# METROPOLITAN GOVERNMENT OF NASHVILLE AND DAVIDSON COUNTY

## STAFF RECOMMENDATION 1206 Cedar Lane July 15, 2015

**Application:** New construction- outbuilding; Setback determination  
**District:** Belmont-Hillsboro Neighborhood Conservation Zoning Overlay  
**Council District:** 18  
**Map and Parcel Number:** 11801009700  
**Applicant:** Tyler LeMarinel, Allard Ward Architects  
**Project Lead:** Paul Hoffman, paul.hoffman@nashville.gov

**Description of Project:** An application for construction of an outbuilding (not a detached accessory dwelling unit) of nine hundred and seventy square feet (970 sq. ft.) at the rear of the lot. A setback determination is requested from twenty feet (20') to ten feet (10') from the rear property line, and from five feet (5') to three feet (3') on the side.

# A0.1

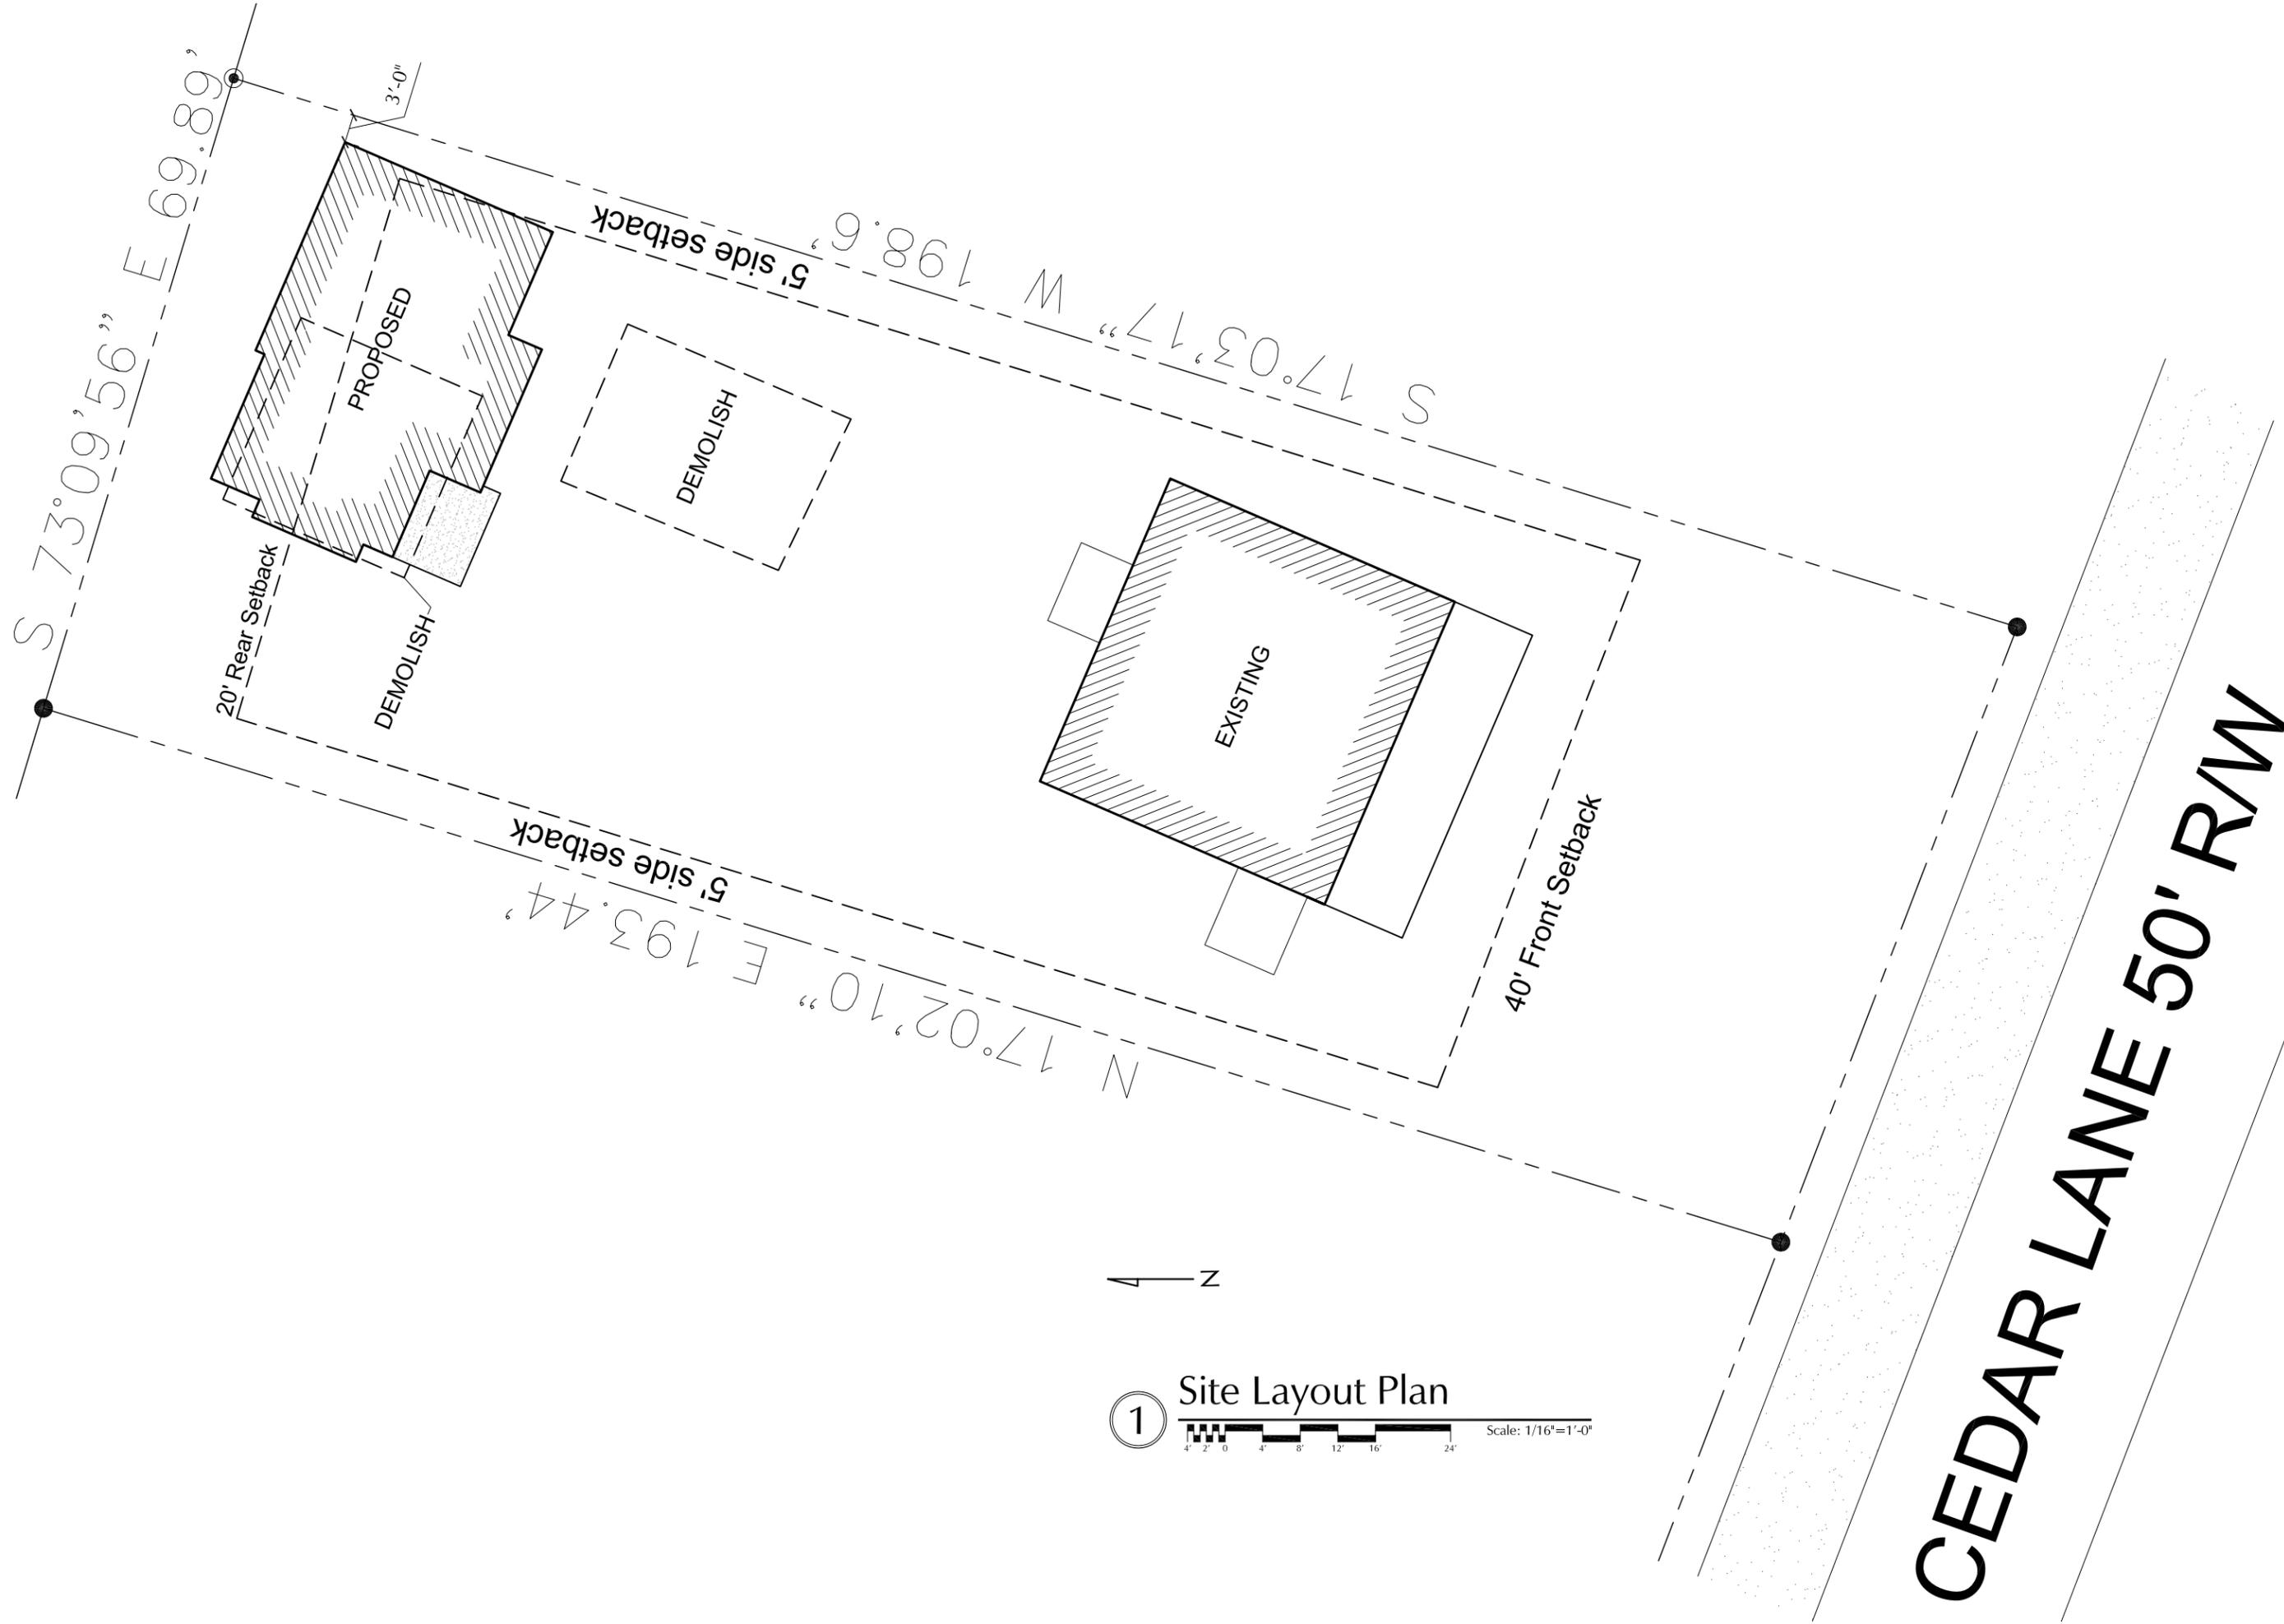
The proposed outbuilding requires a redetermination of the rear and side setbacks. The base zoning requires that an outbuilding larger than seven hundred square feet (700 sq. ft.) be twenty feet (20') from the rear and five feet (5') from the side property line. The outbuilding is proposed to be ten feet (10') from the rear property line and three feet (3') from the side instead. There are several outbuildings nearby that are closer than these dimensions from both rear and side property lines, and this is a normal condition in the district. Staff therefore recommends approval of the setback determination
